This addendum forms a part of the Contract Documents and modifies the original Bidding Documents dated April 2024, and consists of pages AD2-1 thru AD2-2 and attachments. The following changes, additions and/or deletions shall be made to the following documents; all other conditions shall remain the same.

**ITEM NO. III – CLARIFICATION/RFI RESPONSES**

**FOR: PROJECT NO. 9557820  
MAIN HOSP RADIOLOGY CT SCAN SITE TRAILER  
UNIVERSITY OF CALIFORNIA  
UC DAVIS HEALTH  
SACRAMENTO, CALIFORNIA**

NOTE: CENTER MASS OF ELECTRICAL EQUIPMENT TO BE LESS THAN 48" AFF PER HCAI PIN 68

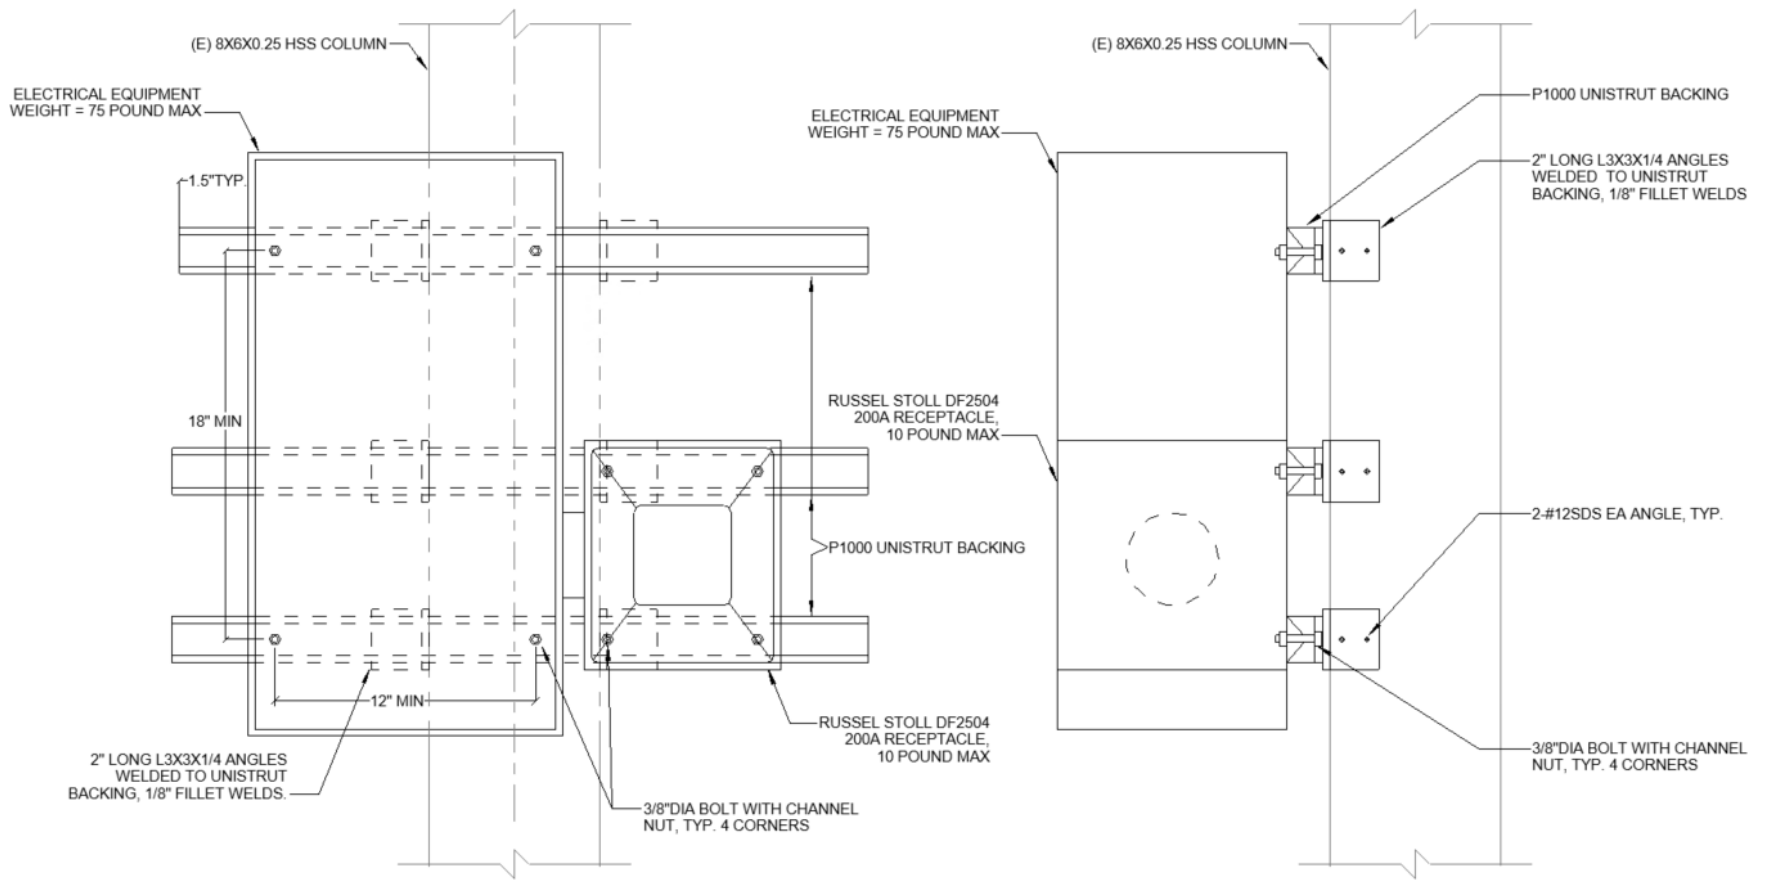
BID RFI-14: Please provide mounting detail for the new 200A fused disconnect to serve CT Trailer

RESPONSE: Mount 200A disconnect to the existing Utility HSS column (Refer to Utility Column 6/A4.1) per the attached detail. This will be a future ACD to OSHPD.

**Figure 6 - Russellstoll Receptacle / Service Disconnect**

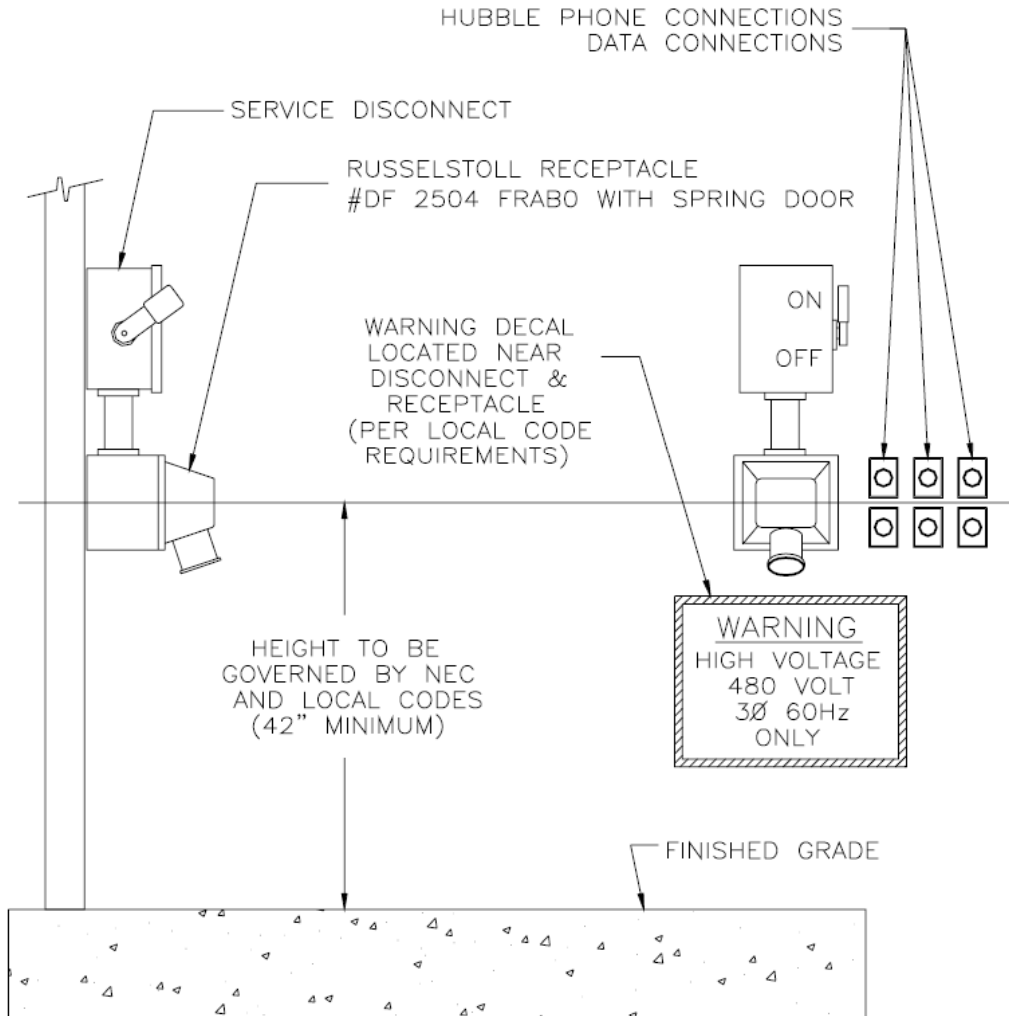
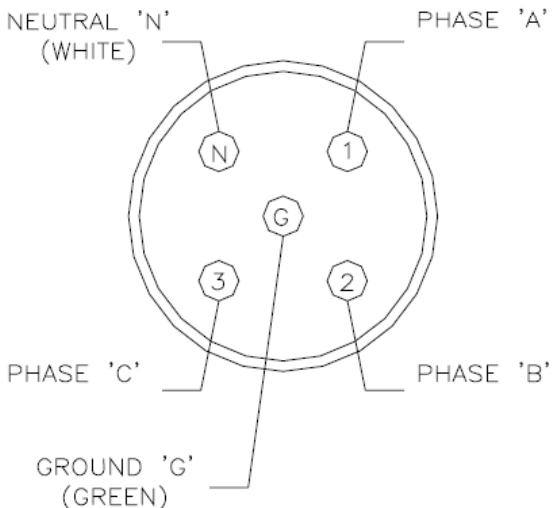
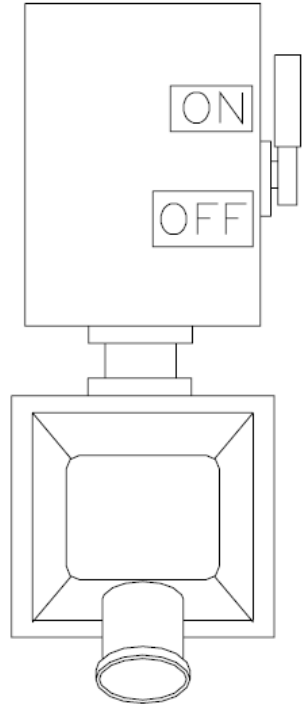
BID RFI-15: Please provide CT Trailer site planning guide, or provide part # of the Russelstol ~~150A~~ receptacle that will be required.

RESPONSE: Refer to Basis of Design/site planning from old Vendor-RAYUS Radiology as noted in Approved Spec Section 11 70 00/ page 22 of 23: Use Part Number: 480 VOLT (200 AMP) 5 WIRE RUSSELLSTOLL RECEPTACLE DF 2504 FRABO-this receptacle must be waterproof.

Also, see attached for new "Site Planning Guide / page 17 by Advanced Mobility via new Vendor-Shared Imaging, which states the same Russellstoll Part Number.
